Product Change Notification

108549 - 01

Change Notification #: 108549 - 01
Change Title: Intel(R) Carrier Grade Server TIGH2U, PCN 108549-01, Product Design, Revised IDE cable fold and Boot Bank Selection Jumper standard shunt, Reason for Revision: Update TA revision numbers
Date of Publication: January 13, 2009

Location of IDE cable and BBSJ on a NSC2U server with the top cover removed.

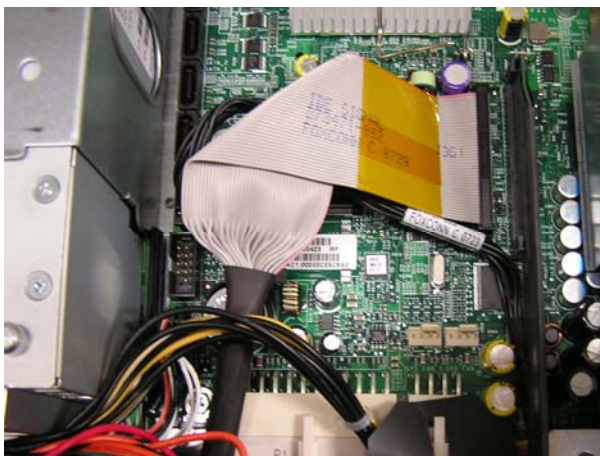
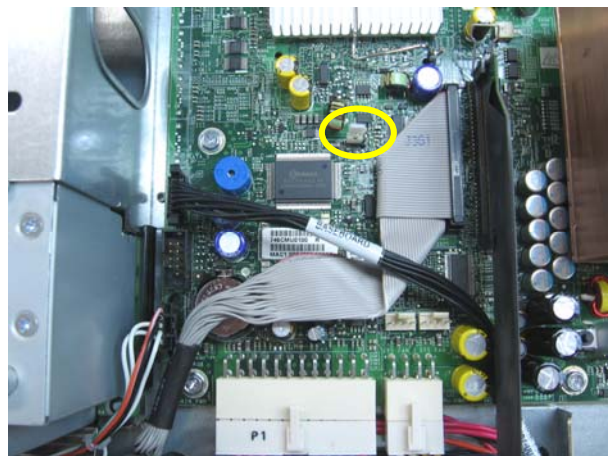
Intel has revised the fold of the IDE cable and removed the tab from the BIOS Bank Select Jumper (BBSJ) to minimize cable intrusion into the PCI keep-out zone.

The IDE cable length and design remain the same. The change to the IDE cable is limited to a revised fold. The revised "tab-less" jumper is a standard shunt.

The photos on the left show the original IDE cable fold with the cable routed over the top of the BBSJ and the USB cable.

The photos on the right show the revised fold and routing. The result of the revised cable routing and fold the IDE cable rests closer to the system board. The BBSJ is exposed and highlighted by a yellow circle.

Close up of original IDE fold & BBSJ

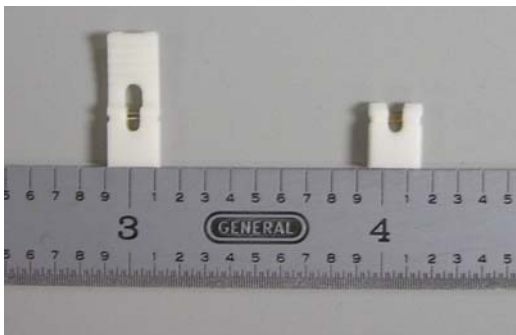
Close up of revised IDE cable fold & original BBSJ

The tab on the original shunt is designed to improve shunt access in the event the position must be changed. The tab-less shunt is a standard shunt used in electronic equipment. The BBSJ is accessed only in the event of a corrupted or failed BIOS update process. Corruption of a BIOS bank is a rare occurrence hence the BBSJ is seldom used.
